工程指示 / 要求簡箋(E.I.)

工程指示編號：EI / 2447 / 20

工程名稱：亞皆老街中電

工程項目：平台制房百葉地盤用鋁板 (LV SWITCH ROOM 1) LG2

AL-501
LG2/F
FAN ROOM

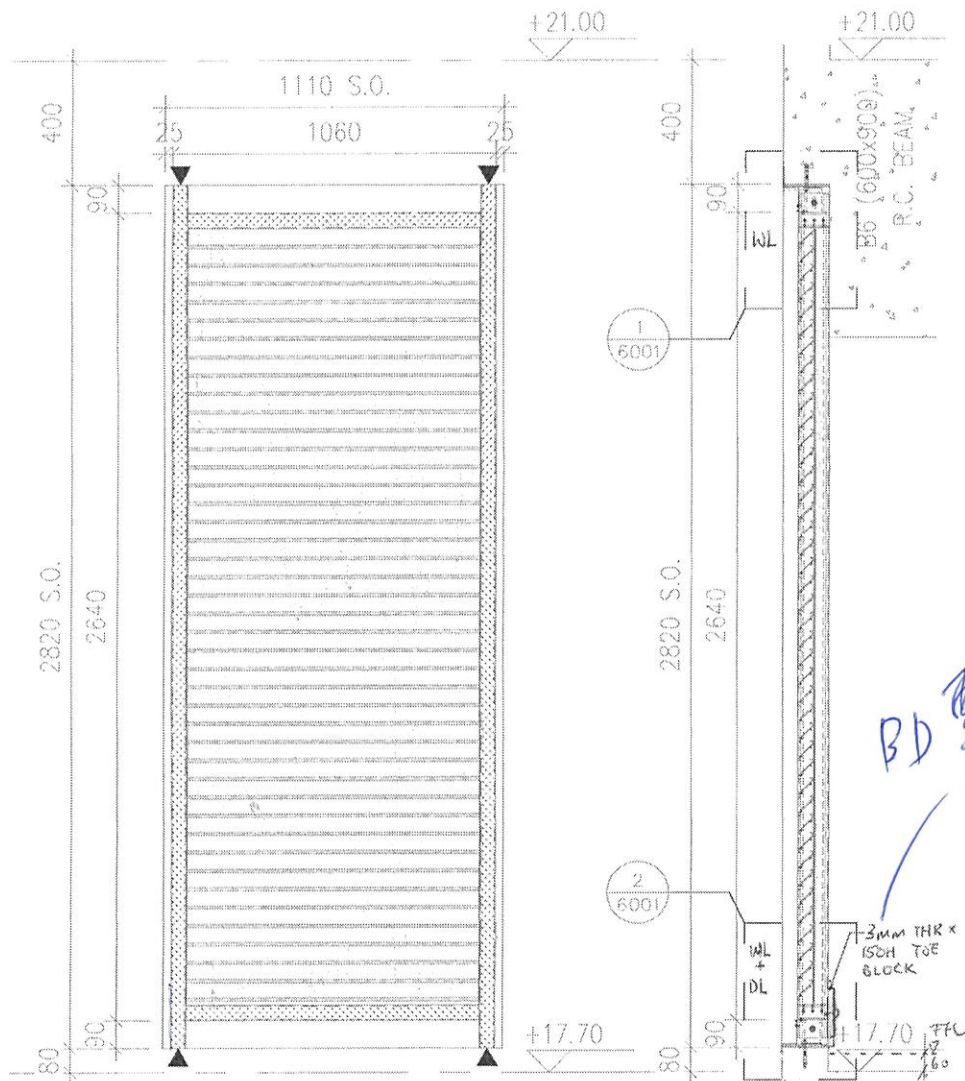
BD 對
是否照P 板

AL-501d
LG2/F
LV SWITCH ROOM 1

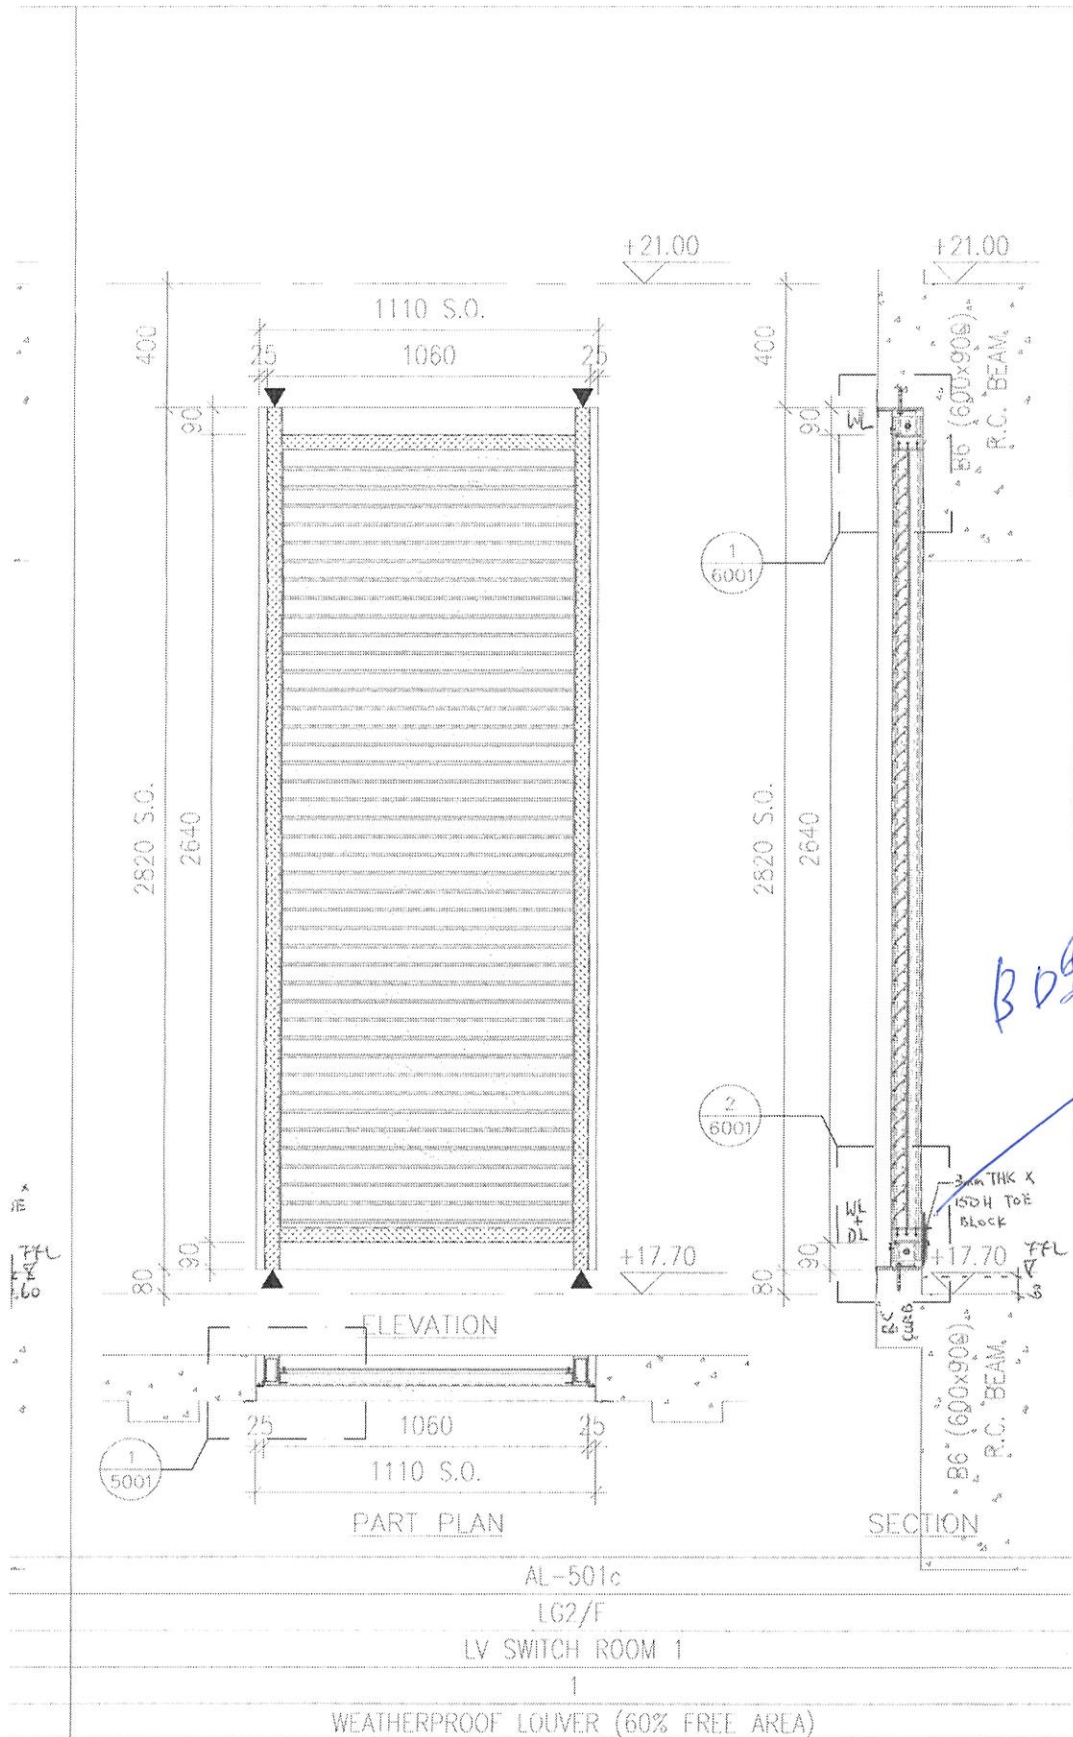
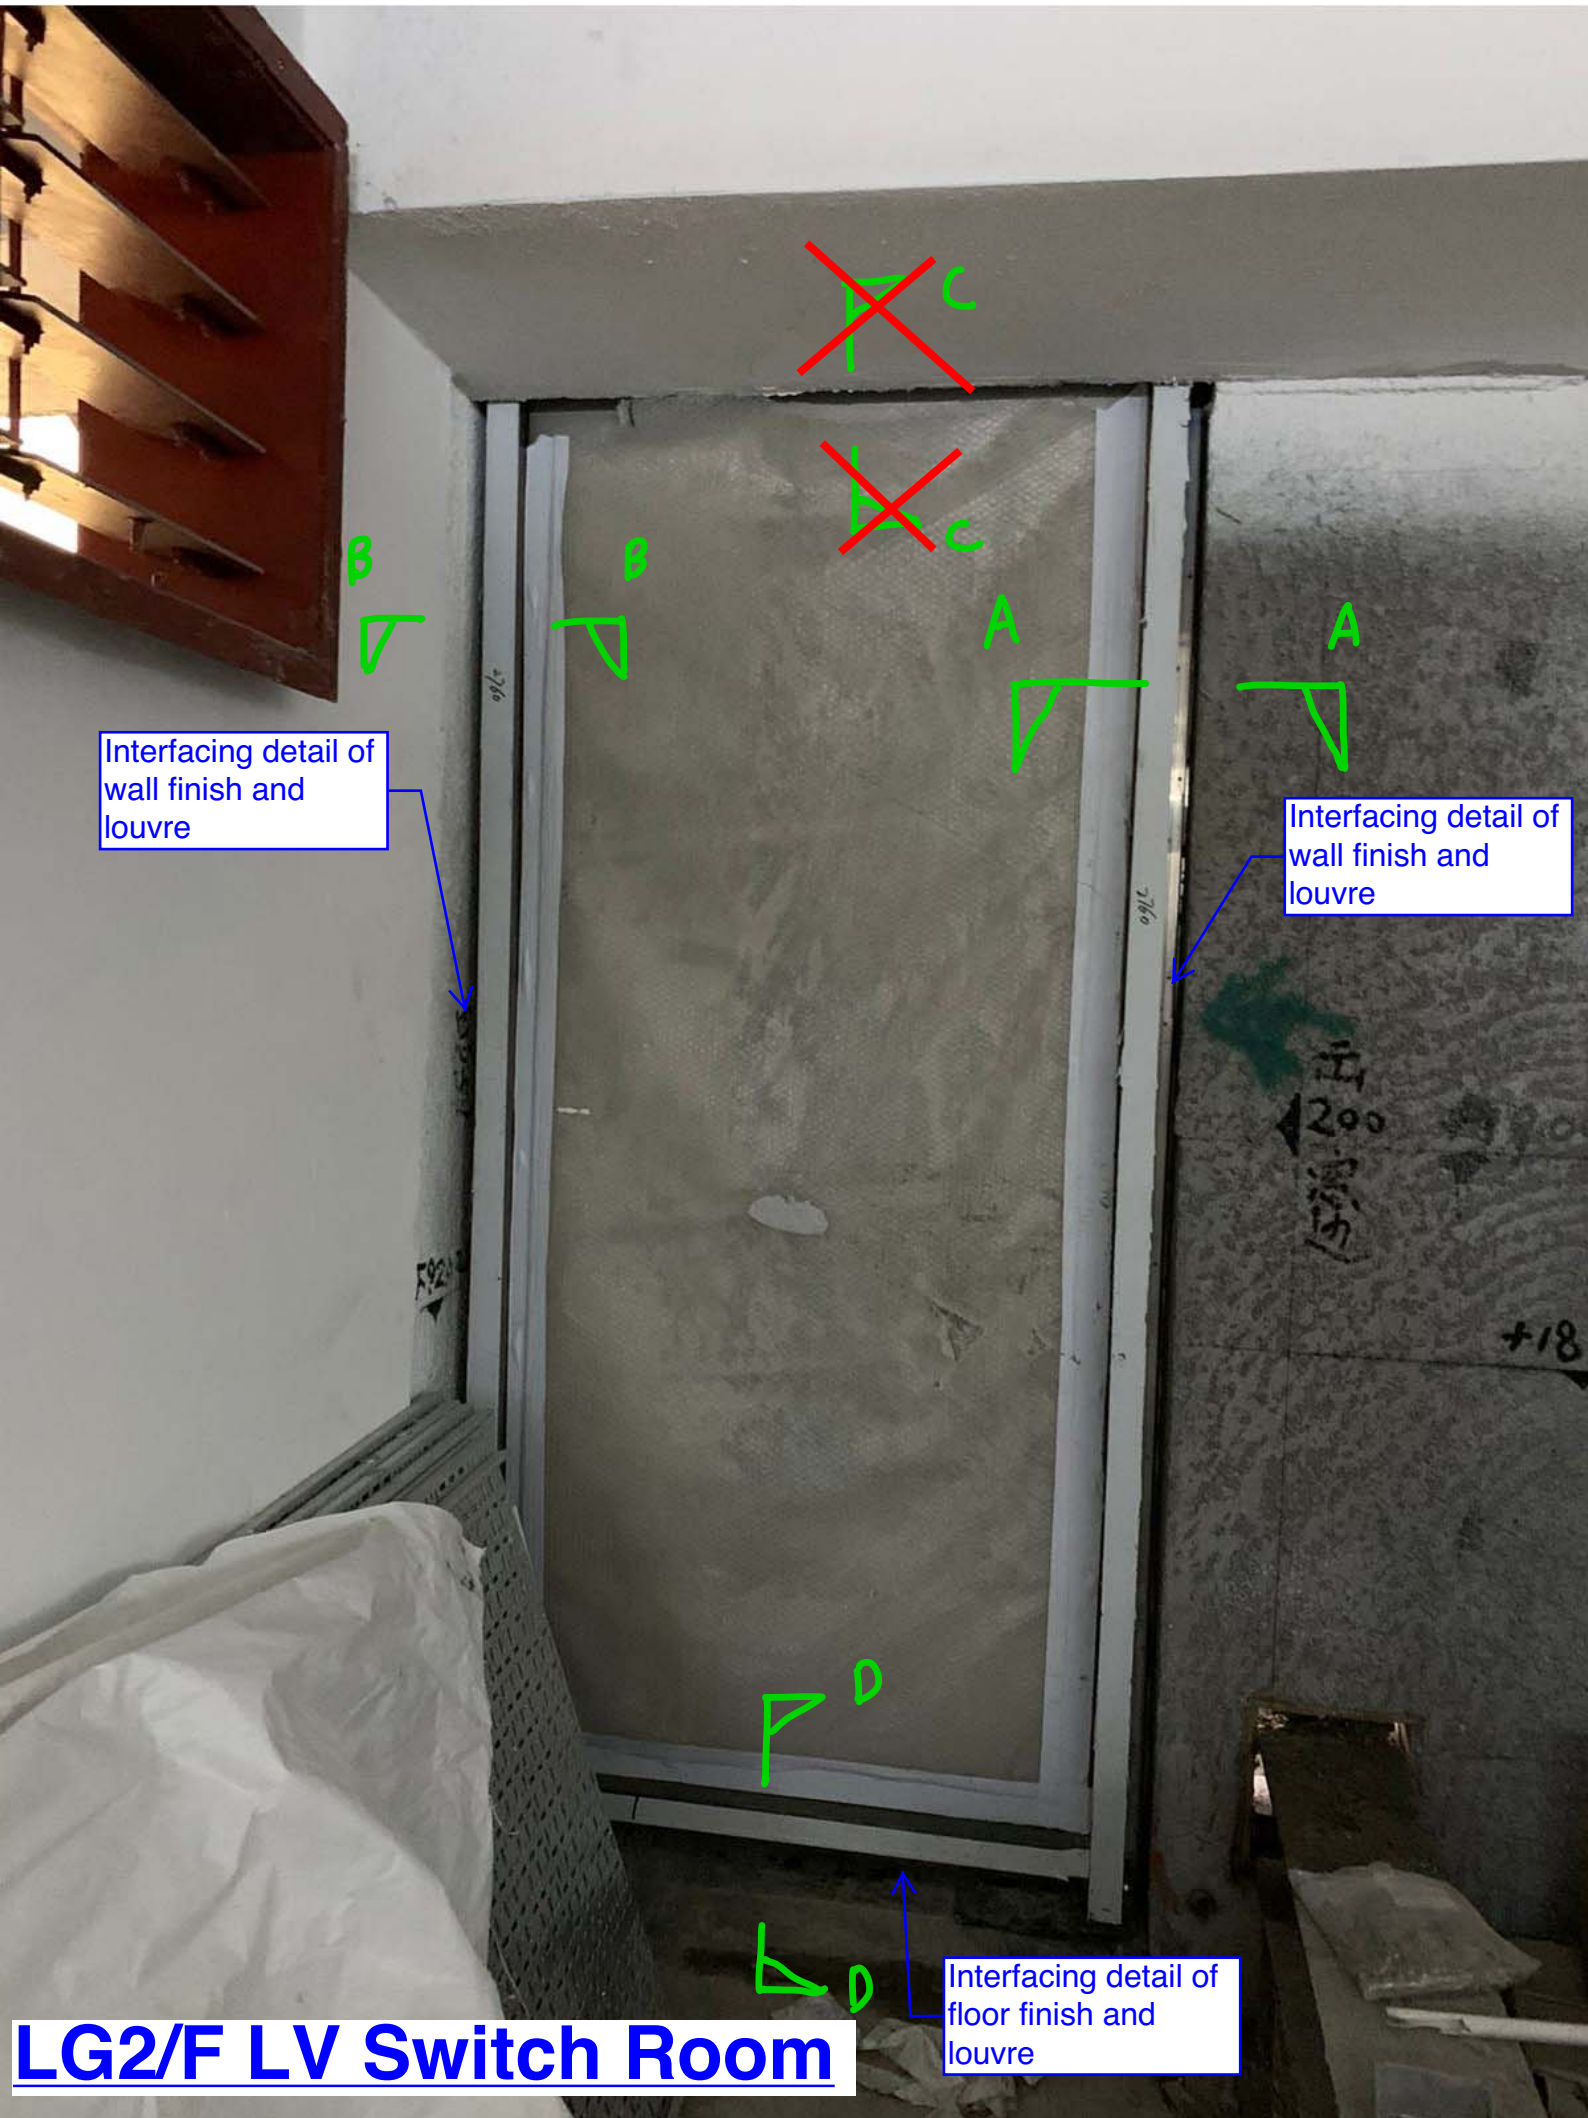
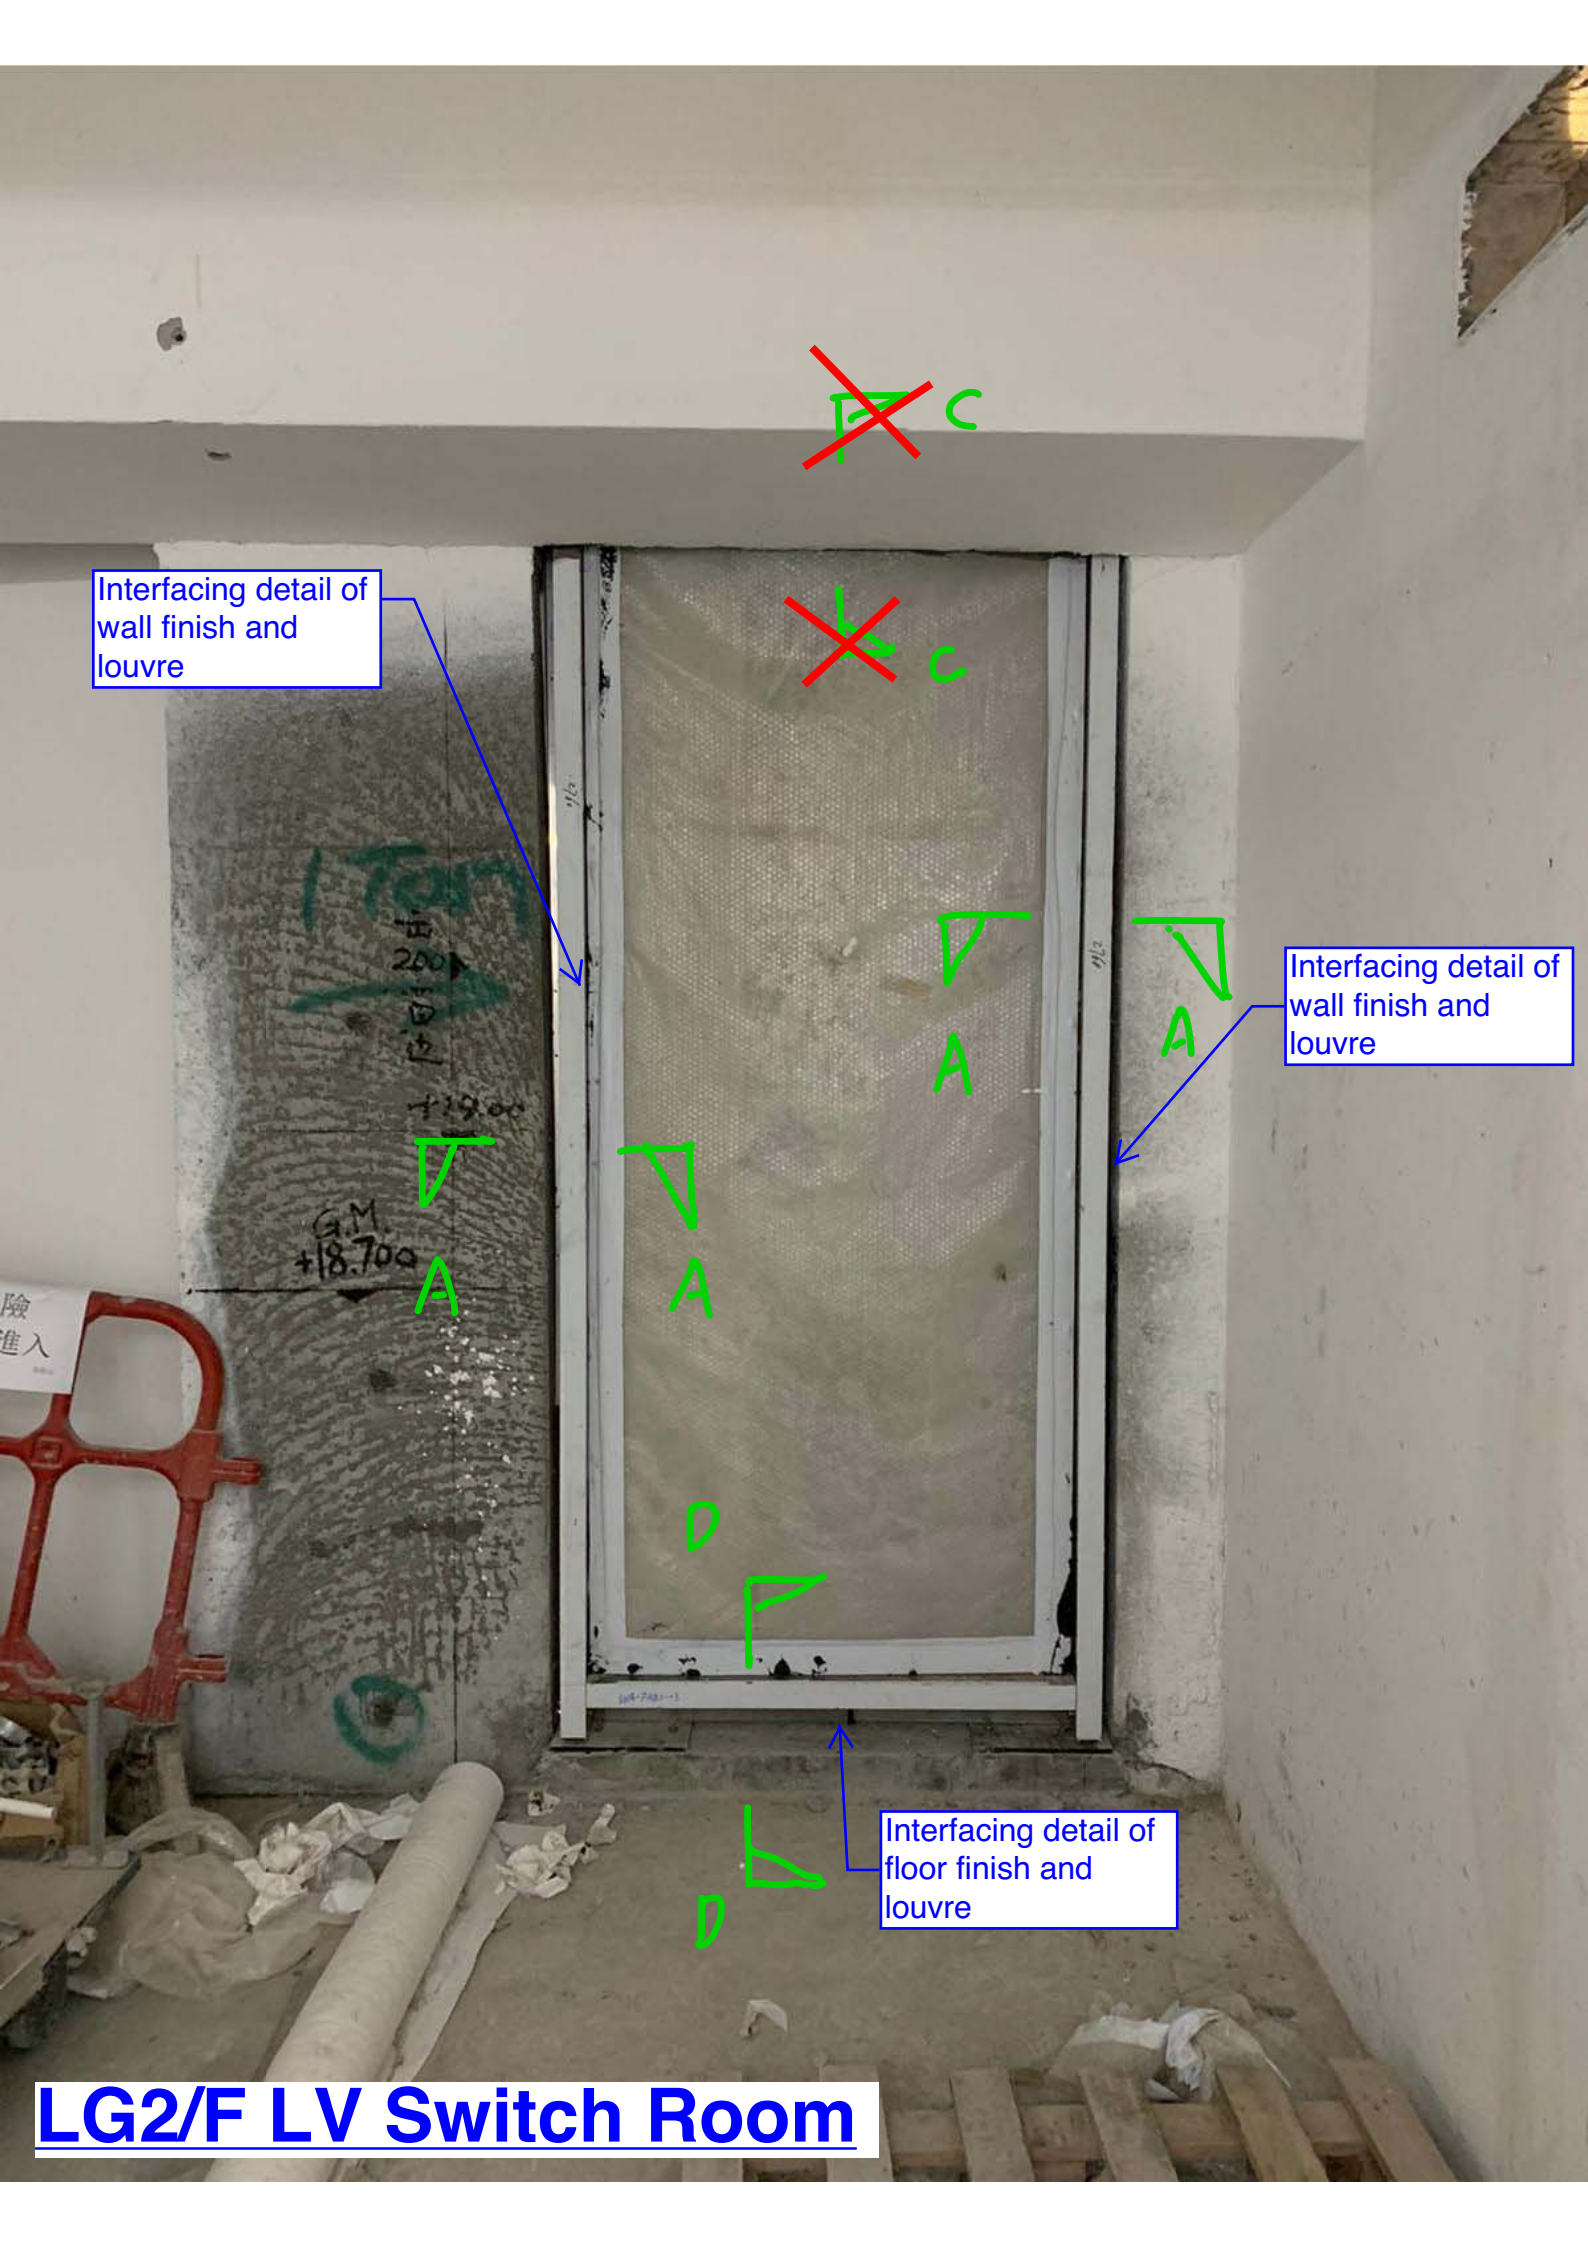
For the top part, no interfacing details provided as there is R.C. beam at the top of louver with reference to the attached drawing.

Moreover, we suggest that grouting is not necessary as flashing is added for four sides of louver for waterproofing.

Please note that flashing is added but no grouting for louver at podium with reference to the attached drawing. Please kindly review the waterproofing issue.

How about the top part? Most of the rooms with external louvre will not have false ceiling and louvre top fixing should be sealed up with the details same the one you proposed for bottom part. All four sides of the louvre need to sealed up at the interfacing with wall opening. Besides, you better seek approval from Sino as this kind of interfacing detail without physical grouting is not a common detail in terms of waterproofing. Regards, Raymond Ho何耀威 Associate Director
助理董事 AGC Design Ltd
www.agcdesign.com.hk<<http://www.agcdesign.com.hk>> 16/F Olympia Plaza 255 King's Road Hong Kong 香港北角英皇道二五五號國都廣場十六樓 (D) 852 25088381 (T) 852 22197188 (F) 852 22197133 (E)
raymondho@agcdesign.com.hk<<mailto:raymondho@agcdesign.com.hk>>

Further to AGC and MFT' s reply yesterday, we will proceed internal finishing works as per attached detail accordingly.

If the interfacing at top part happens to all louvres at Podium that facing Argyle Street, I have no other comments.
